CITY OF VANCOUVER  
COMMUNITY SERVICES GROUP

DEVELOPMENT PERMIT STAFF COMMITTEE REPORT  
NOVEMBER 19, 2014

3603 WEST 27<sup>TH</sup> AVENUE (COMPLETE APPLICATION)  
DE418298 - ZONE C-2

THAT the Board APPROVE Development Application No. DE418296 submitted, the plans and information forming a part thereof, thereby permitting the development of a four-storey mixed-use building containing a grocery store and retail uses on the ground floor and a total of 46 dwelling units (ground to fourth floors), all over three levels of underground parking providing a total of 165 parking spaces having vehicular access from the lane, subject to the following conditions:

Figure 2: East Elevation

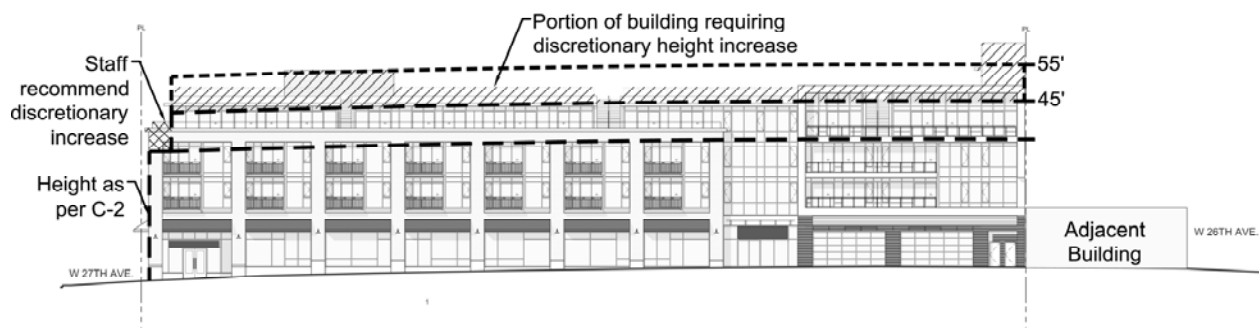
For typical C-2 development sites, a setback of 8 ft. from the front property line is required above the 35 ft. height mark in order to reduce apparent scale and ensure natural light for the public street. The proposal is requesting an intrusion into this setback. along the entire east elevation and a portion of the south. As the location of this floor area at the street side moves it away from the single-family properties at the rear, creates a strong cornice line, and still provides a visual break at the top edge of the building, staff support the request. Staff are recommending Condition 1.3 for the roof deck railings to be moved back behind the setback line to reduce the overall building visual scale.

The walls that define the "block" expression at the northern end of the site also project into the 8 ft. setback. Staff support this limited projection into the setback as it has the effect of a cornice, assists with articulation of the long building elevation, and does not have a negative impact on neighbours.

**Note to Applicant:** The proposed patio railings project into the front setback. This condition can be achieved by moving the railings back so that they are set back at least 8 ft. from the ultimate front property line.

Figure 3: South Elevation

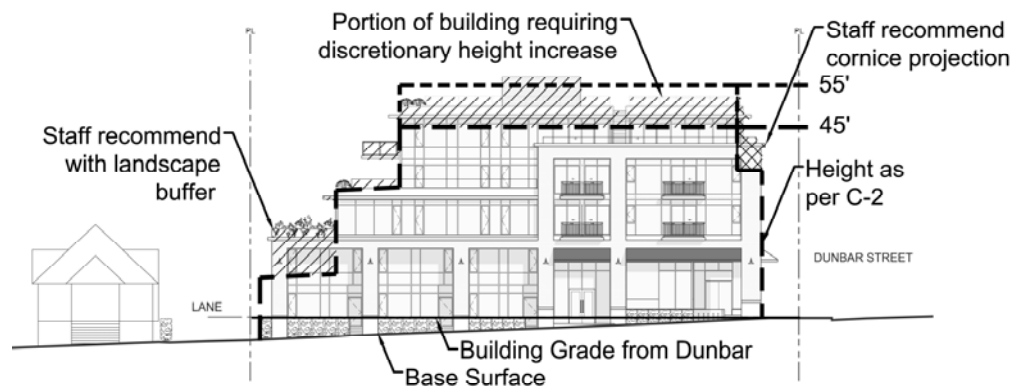
In the C-2 district, the exterior side yard on a corner site is treated as a front yard. Therefore along West 27<sup>th</sup> Avenue, a 2 ft. setback is required for commercial uses and an average 12 ft. setback is required for residential uses. The intent of the increased residential setback is to provide privacy for the units at grade along arterial routes. As these residential units are located facing a residential street, and are raised one to two ft. above grade, the proposed average setback of 8.09 ft. is considered supportable as it provides adequate open space and buffer for the living space.
